Anonymous Referee #1

Referee #1' s comments:

Figure 2: Comparison of the hydrographs at 6 gauging stations provided by 3 FLEX-SD models using 5% best-performing parameter sets

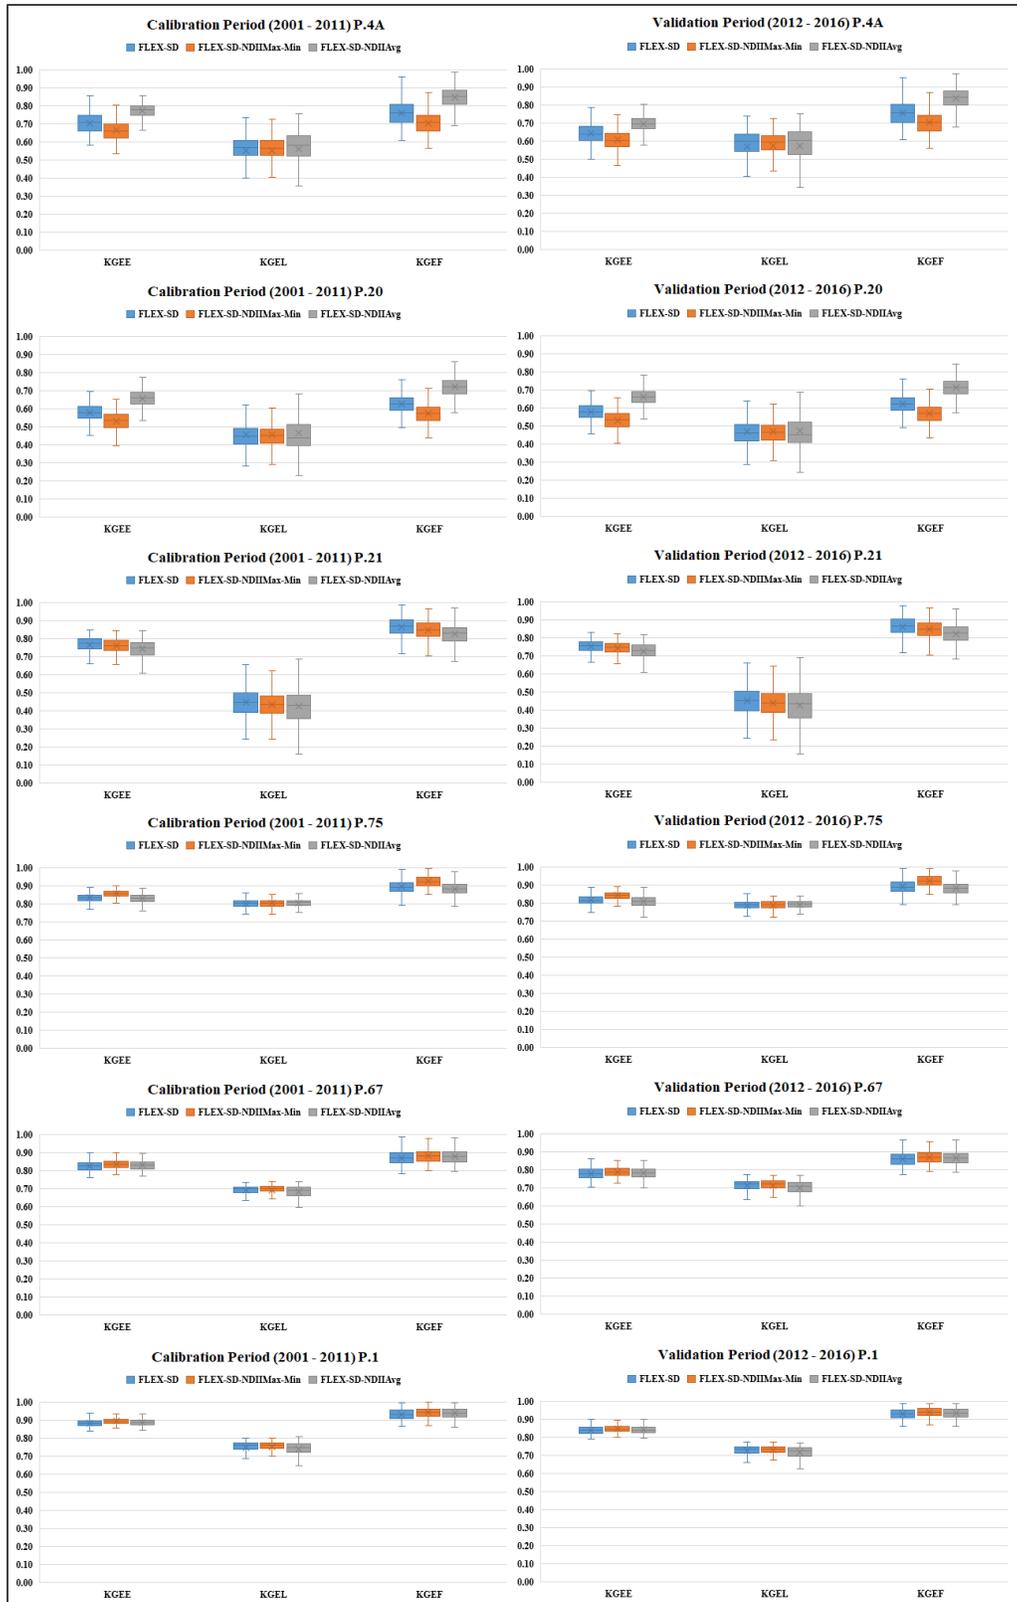
The main point here is that the research gaps motivating the present work and the innovative contribution to the literature are not clearly stated. As for results, a key issue is the estimation uncertainty, which should be quantified for model comparison in terms e.g. of prediction intervals. Due to the large number of calibration parameters, it is expected for the prediction intervals to be almost large. Hence, a fundamental aspect of this work should be how the information introduced here for calibration affects the prediction intervals (the estimation uncertainty) for different model structures. Note that only at the end of the manuscript (in the Conclusion Section) the Authors justify their work as a method to avoid uncertainty in runoff estimation (which is not avoidable in my opinion, but it can be reduced).

FLEX-SD, FLEX-SD-NDII_{Max-Min} and FLEX-SD-NDII_{Avg} were calibrated (2001-2011) and validated (2012-2016) at P.1 station using 50,000 random parameter sets which were determined using the MOSCEM-UA algorithm by finding the Pareto-optimal solutions defined by three objective functions. These include the Kling-Gupta Efficiencies for high flows, low flows, and the flow duration (KGEE, KGEL and KGEF) respectively. To evaluate estimation uncertainty, the 5% best-performing parameter sets were identified as feasible (Hulsman et al., 2019) and were utilized to evaluate model performance. All around 2,500 parameter sets were used to create the box plots of KGEE, KGEL and KGEF at the calibrated station (P.1) and at 5 upstream stations (P.20, P.4A, P.21, P.75 and P.67) (see Figure 1). The box plots provided by all models at P.21, P.75, P.67 and P.1 are similar, while FLEX-SD-NDII_{Max-Min} performed slightly better than FLEX-SD and FLEX-SD-NDII_{Avg}. However, the box plots of KGEE and KGEF contributed by FLEX-SD-NDII_{Avg} at P.4A and P.20 (tropical forest catchments) are exceptionally better than FLEX-SD and FLEX-SD-

NDII_{Max-Min}. Observed and calculated hydrographs acquired from the 5% best performing parameter combinations using FLEX-SD-NDII_{Avg} at P.4A and P.20 show a narrow band compared to other 2 models but very similar at other stations, since all 3 KGE values of all models are similar, as shown in Figure 2.

In the revised paper, we shall present and discuss the model uncertainty, as required.
